Technical Service Bulletin: tsb100757

New Cylinder Heads and Rocker Housing Mounting Capscrew

This Technical Service Bulletin introduces new ISM, QSM11, M11, L10, and L10G cylinder heads.

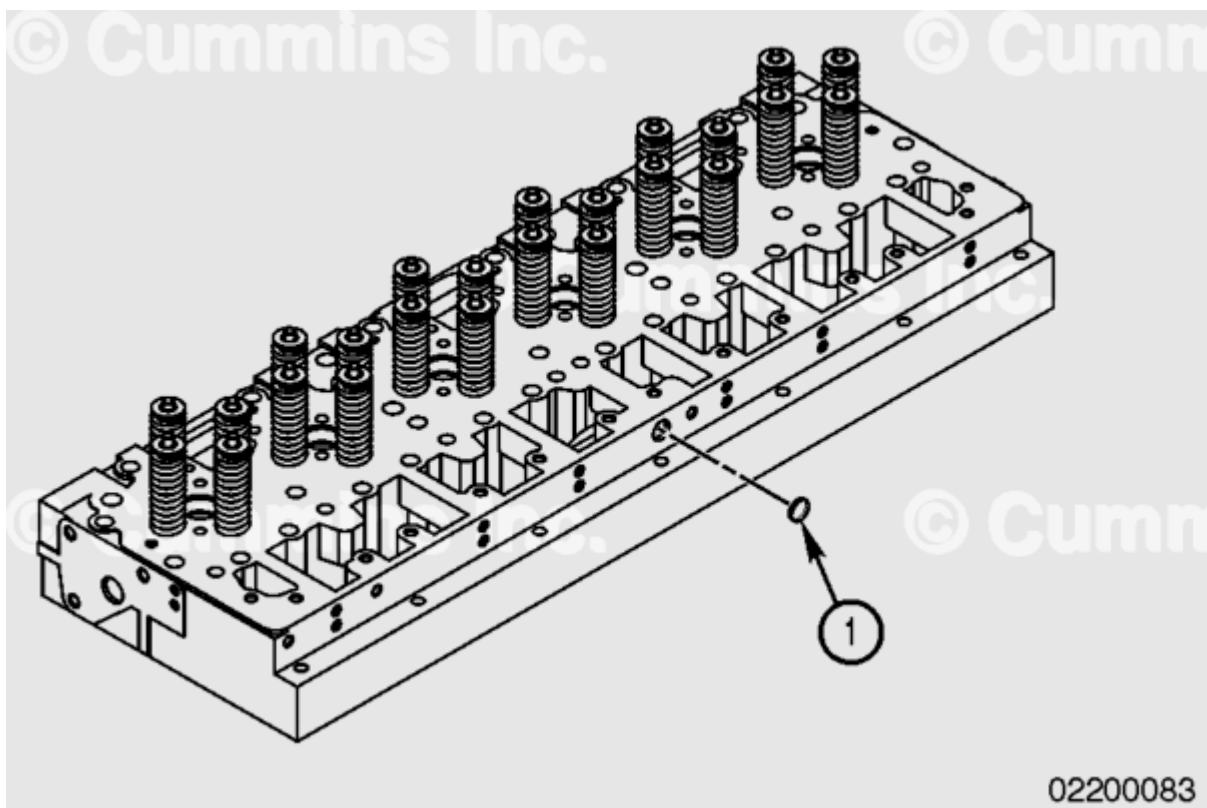
3. A new rocker housing gasket was also released with the new cylinder heads.
4. Several of the new cylinder heads require the use of a cup plug, Part Number 205401, which is **not** included with the cylinder head. This cup plug is used to seal off the air compressor supply port on the intake side of the cylinder head, when the engine is either not equipped with an air compressor or the air compressor intake air is plumbed elsewhere, as shown below. The cylinder head part numbers which require the use of this cup plug are identified in Table 1.
